## **Proposal for Supplement 5 to the 01 series of amendments to UN Regulation No. 129 (Enhanced Child Restraint Systems)**

### **Submitted by the expert from France**

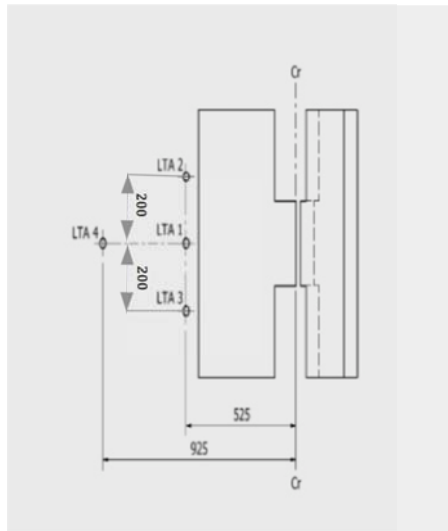
**If present, the lower tether shall be adjusted to achieve a tension load of minimal 50 +/- 5N.**
